NOTICE OF DECISION

DATE:July 17, 2023PROJECT NAME:Earsley Investments Car DetailingPROJECT LOCATION:106 & 108 Yelm Ave W, Yelm, WA 98597PARCEL NUMBER(S):85800100100 & 85800100200CASE NUMBER:MU 2022.0065

Administrative Site Plan Review mu 2022.0065 Findings of Fact, Conclusions of Law, and Decision

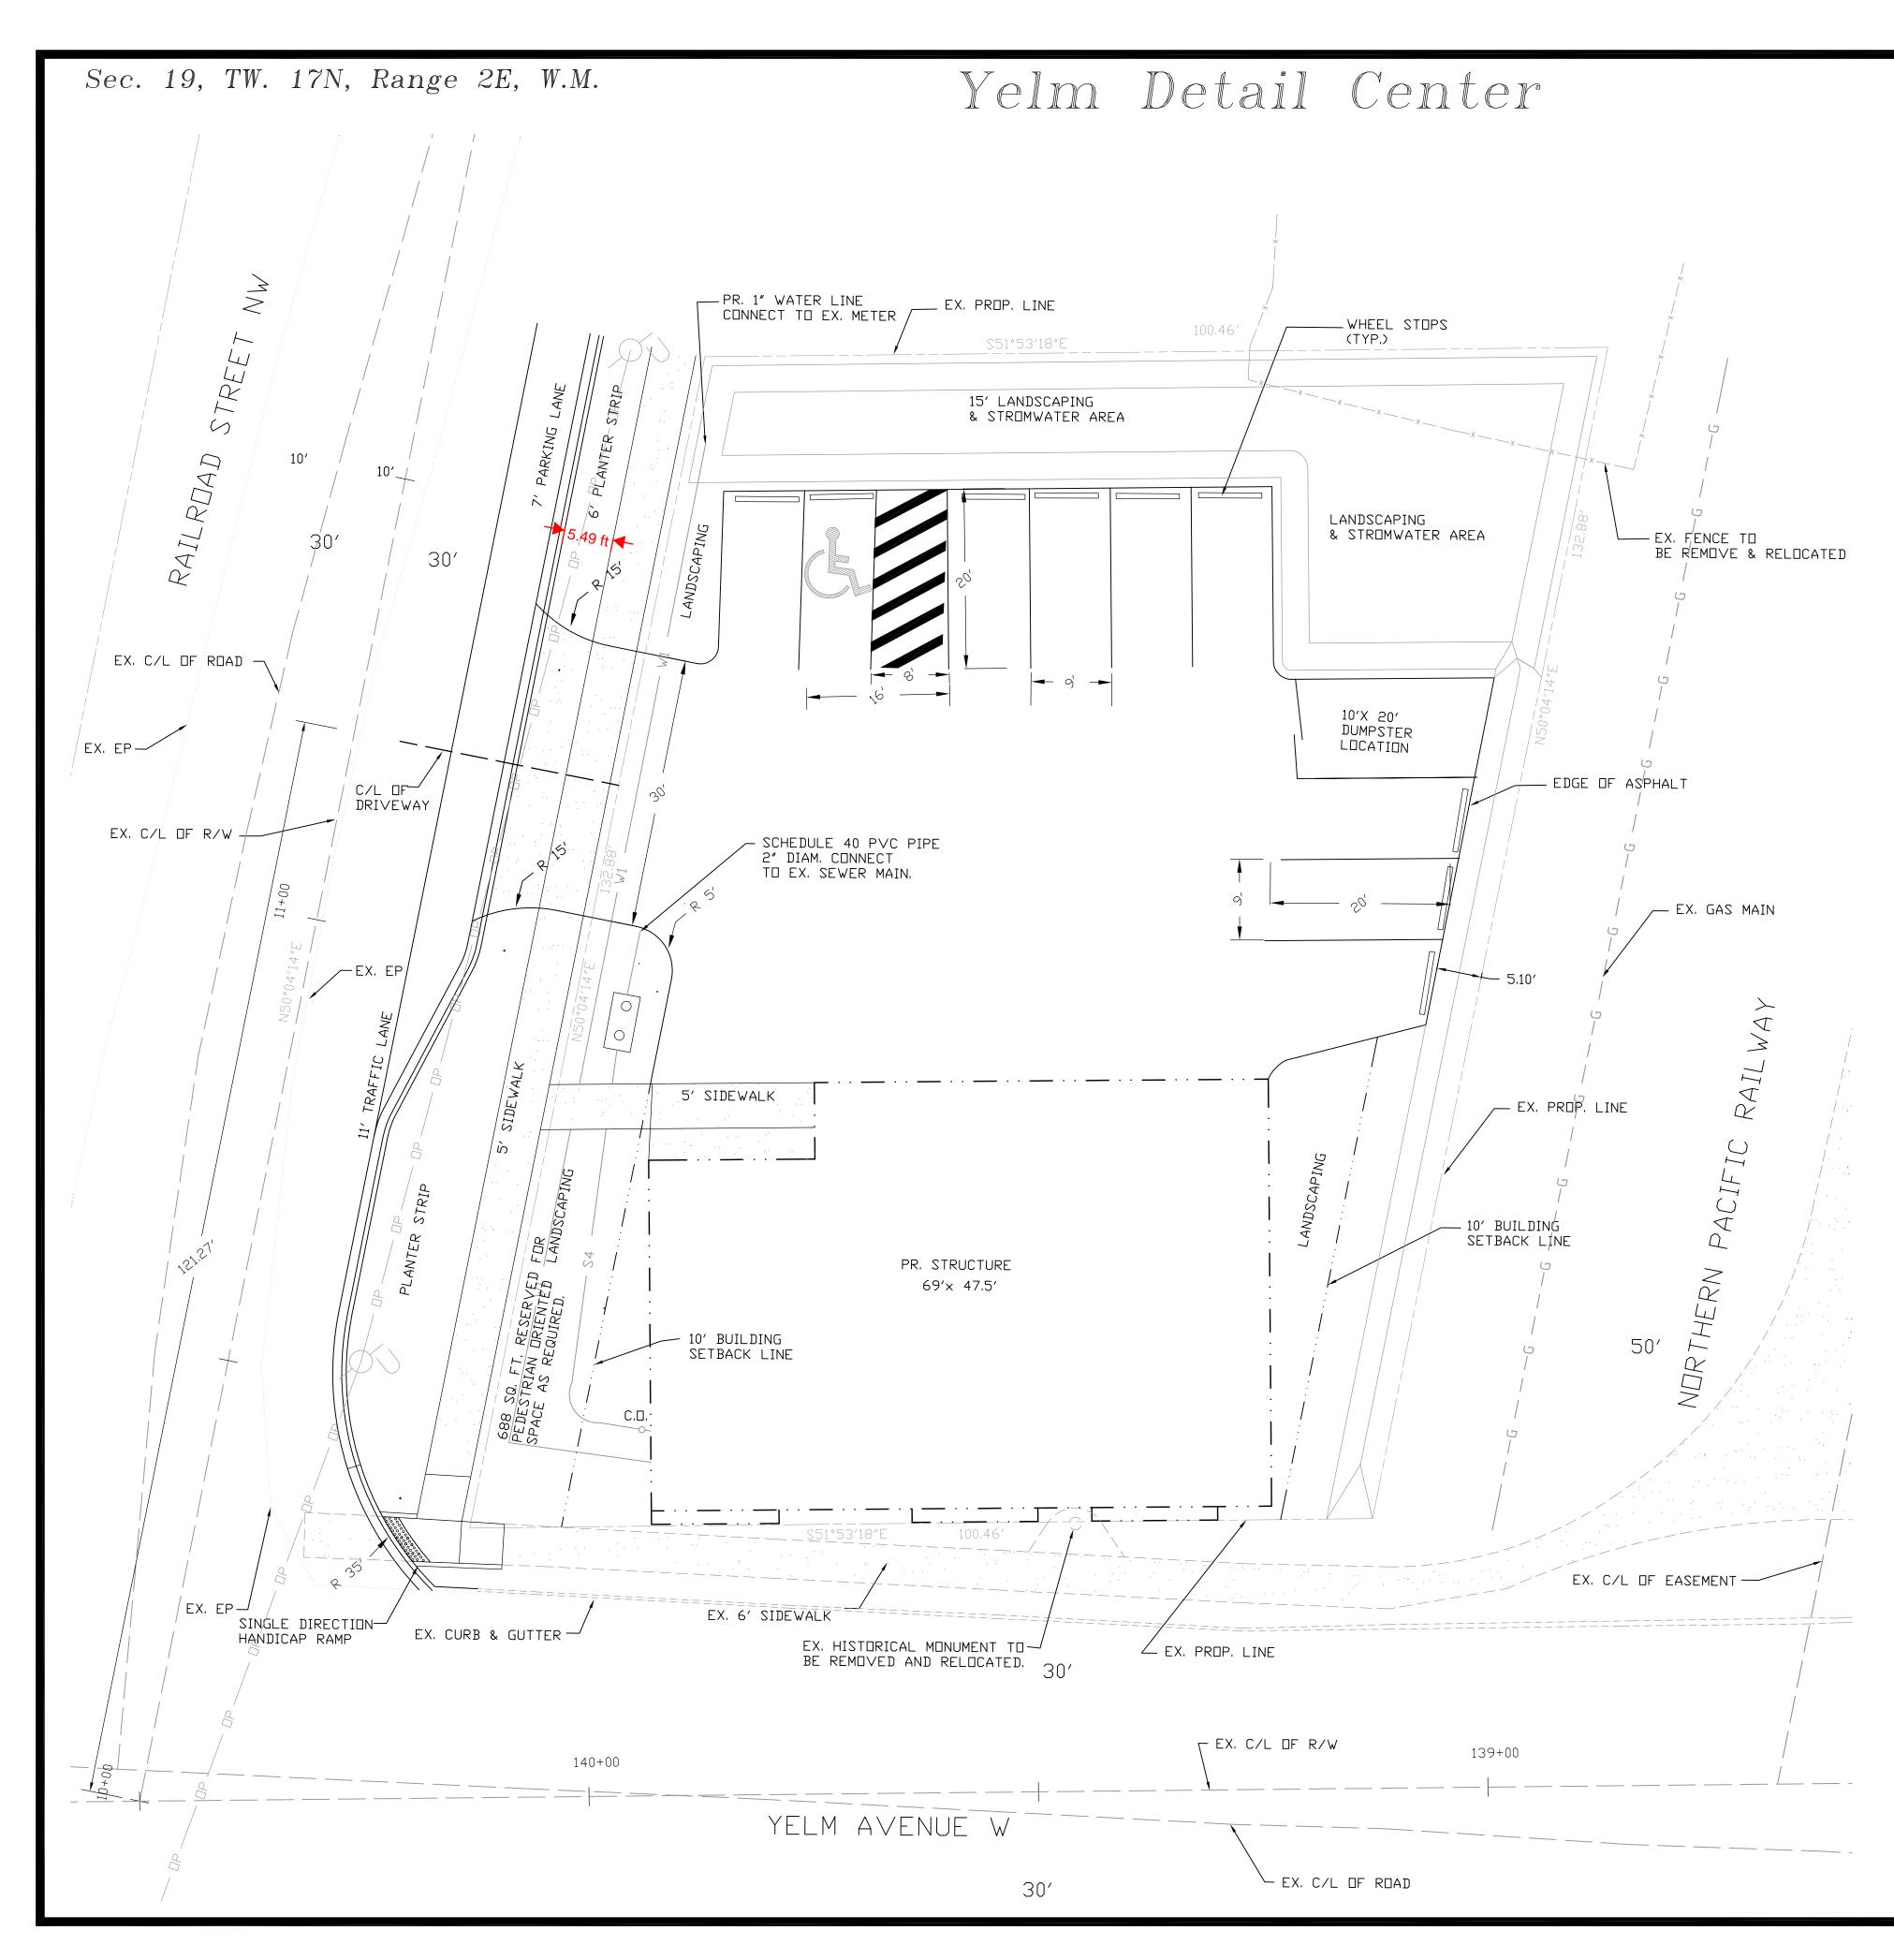
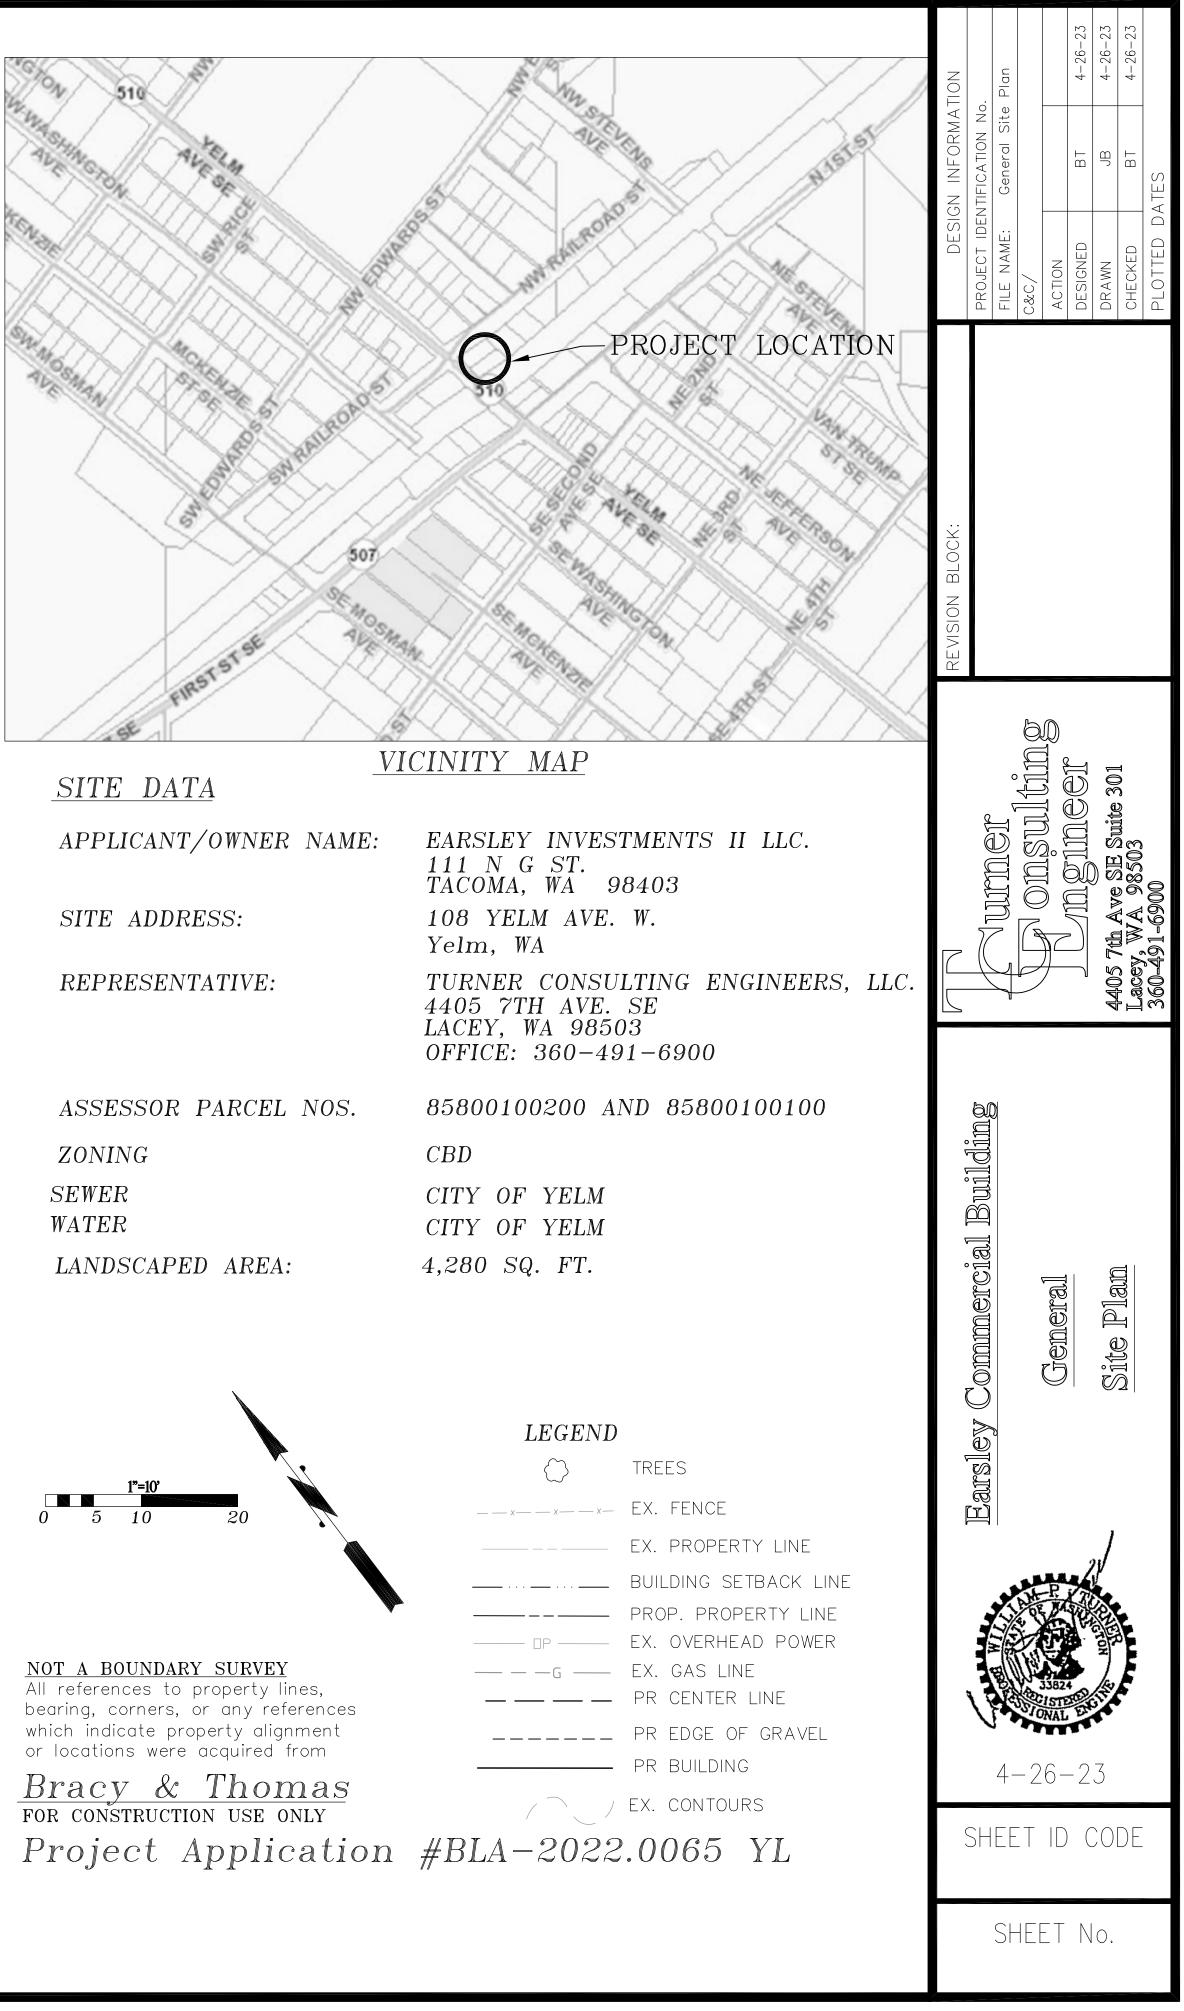
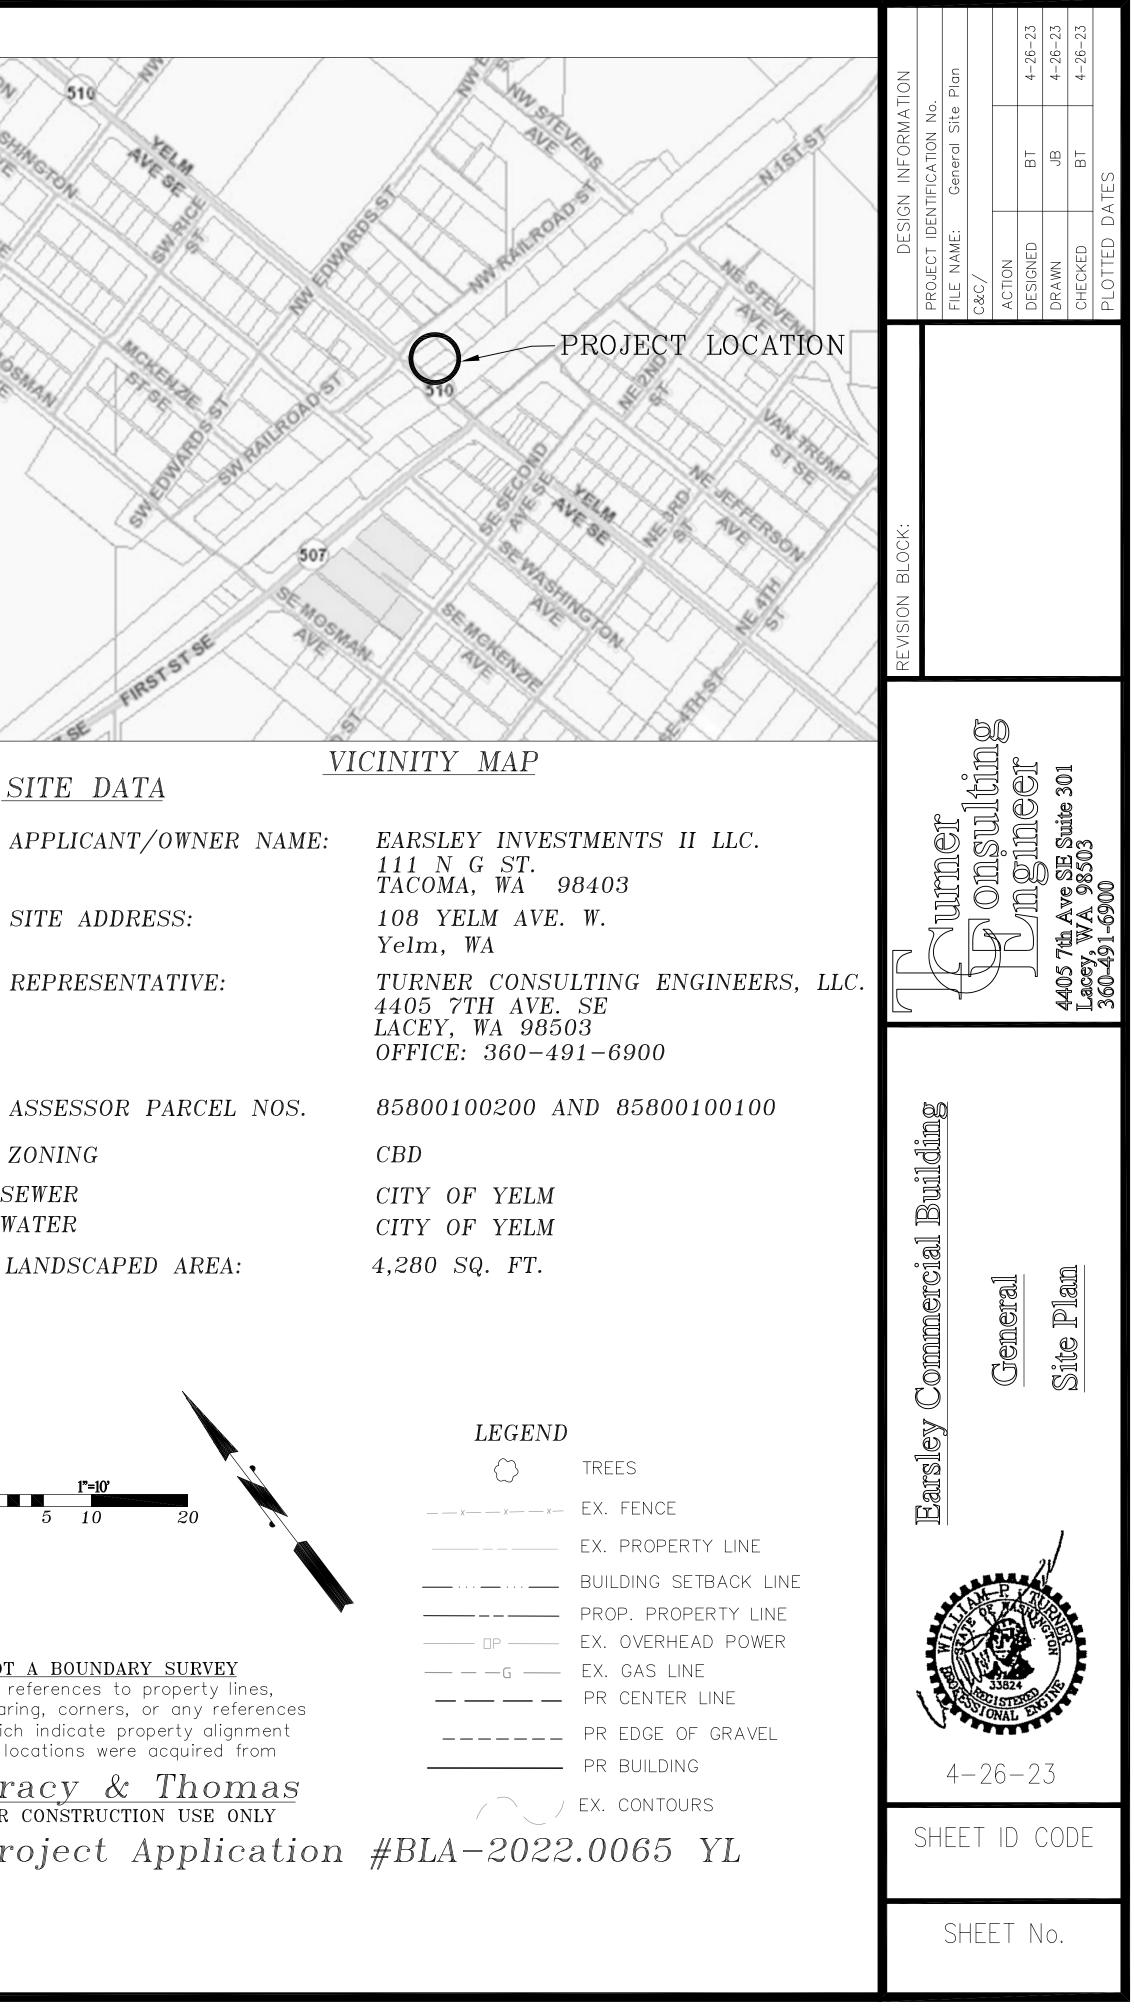
- 1. All the comments shown on the site plan must be addressed.
- 2. The review comments on the landscape plan haven't been addressed yet. A landscape plan that complies with all City rules and Unified Development Code requirements must be submitted with the civil plans.
- 3. The Fire Impact Fee must be paid at the time the building permit is issued.
- 4. Traffic Facility charges are required at the time the building permit is issued.
- 5. The property borders by Yelm Avenue West and Railroad Street Northwest, both of which are not up to City standards. To satisfy City standards, the Railroad Street NW side of the property must be improved.
